Report: TAB Report
Function: Test, Adjust, & Balance
Date: 12/05/2025
Completed By: National TAB

PROJECT
12-15-25 QT #1405 GILBERT, AZ

Project: 12-15-25 QT #1405 GILBERT, AZ

Project Issue Information

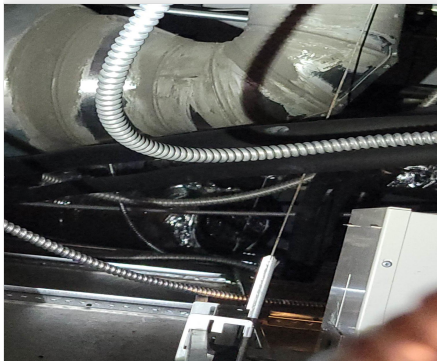
Issue Name : RTU-3 DAMPERS INACCESSIBLE
Description : Dampers are inaccessible. Cannot be properly balanced. Recommend waiting to install kitchen tiles until balance is completed or making them more accessible.
Created By : National TAB **Assigned To :** National TAB - Dan Hertenstein
Status : Open
Priority : High **Asset Tag :** RT-3
Originated Date : 12/17/2025 - Christine Weale - National TAB
